Concurrency issues in the PSE state diagram (D3.1) v102

145.2.5.7 State diagrams

Figure 145–15—Primary Alternative dual-signature semi-independent PSE state diagram

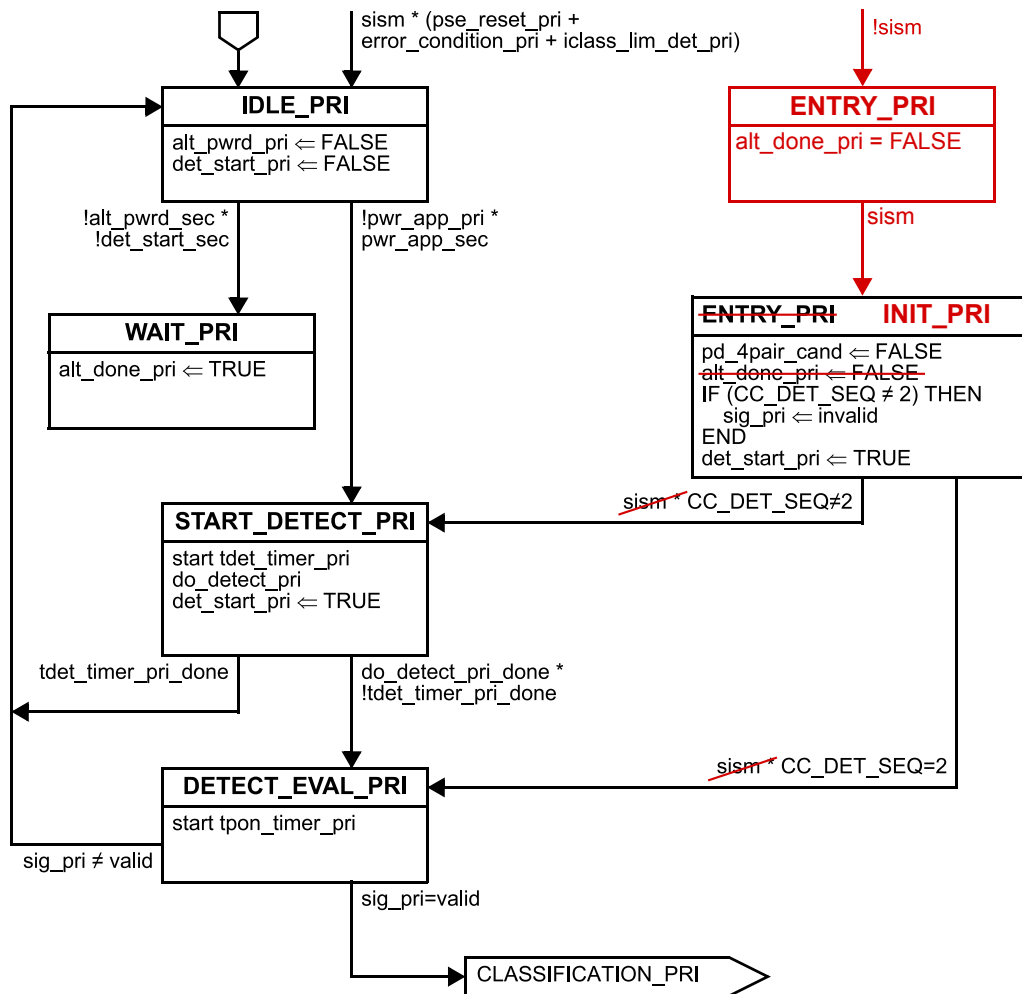
There is an issue in the PSE state diagram where when `sism=FALSE`, both the toplevel state diagram and the Primary/Secondary state diagrams write in variables `pd_4pair_cand`, `sig_pri`, and `sig_sec`. This happens because of the assignment statements in the `IDLE_PRI` and `IDLE_SEC` states. In this baseline these are disabled by introducing a new holding state for the Primary and Secondary SISM state diagrams.

Change Figures in 145.2.5.7 as follows:
